Access Compliance Report

Public Rights-of-Way

(Curb Ramps)

Intersection ID: 10748	Main Street: JOHNSON_ST	Cross Street: POLK_ST	Location: SW
ADA ID: 0D58F1B1B7F0	Ramp Type: Perp	Initial Pass/Fail: Fail	Overall Compliance: No
Codes/Mitigation Info/Possible Solution			Severity Score: 10
			Field Measurements/Component Compliance

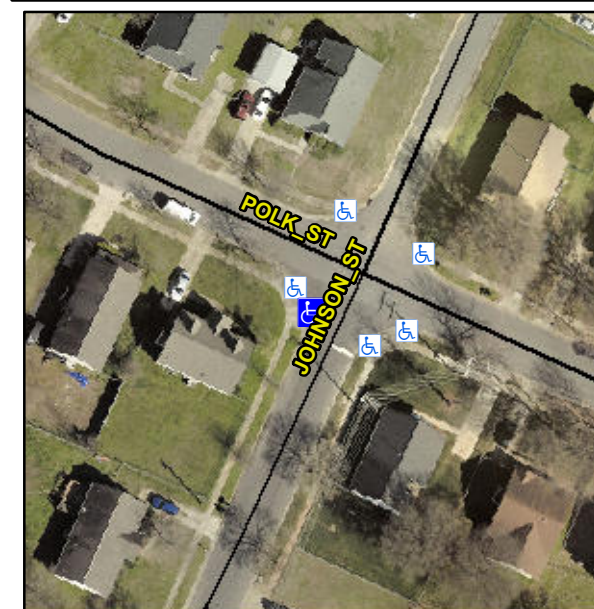
Not Found, R304.5.1, R304.5.3

Compliance	Description	Data	Compliance	Description	Data
N/A	Ramp Length (in)	113.0	Yes	Ramp Slope (%)	7.1
No	Ramp Width (in)	46.0	No	Ramp XSlope (%)	3.0
N/A	Flare Type LT	N/A	N/A	Flare Type RT	N/A
N/A	Flare Slope LT (%)	N/A	N/A	Flare Slope RT (%)	N/A
N/A	Flare Traversable LT?	N/A	N/A	Flare Traversable RT?	N/A
N/A	Landing Length (in)	N/A	N/A	DWS Provided?	N/A
N/A	Landing Width (in)	N/A	N/A	DWS Contrast?	N/A
N/A	Landing Slope (%)	N/A	N/A	DWS Length (in)	N/A
N/A	Landing X Slope (%)	N/A	N/A	DWS Full Width?	N/A
N/A	Landing Curb? (Y/N)	N/A	N/A	DWS Offset (in)	N/A
N/A	Shared Landing?	N/A			
N/A	Gutter Ponding?	N/A	N/A	Gutter Slope (%)	N/A
N/A	Gutter Lip Ht (in)	0.5	N/A	Gutter X Slope (%)	N/A
N/A	Painted X Walk1?	No	N/A	Painted X Walk2?	N/A
	X Walk 1 Direction	To SE		X Walk 2 Direction	N/A
N/A	X Walk 1 Width (in)	N/A	N/A	X Walk 2 Width (in)	N/A
	X Walk 1 Slope (%)	3.7		X Walk 2 Slope (%)	N/A
	X Walk 1 X Slope (%)	0.9		X Walk 2 X Slope (%)	N/A

Remove & Replace Entire Ramp.
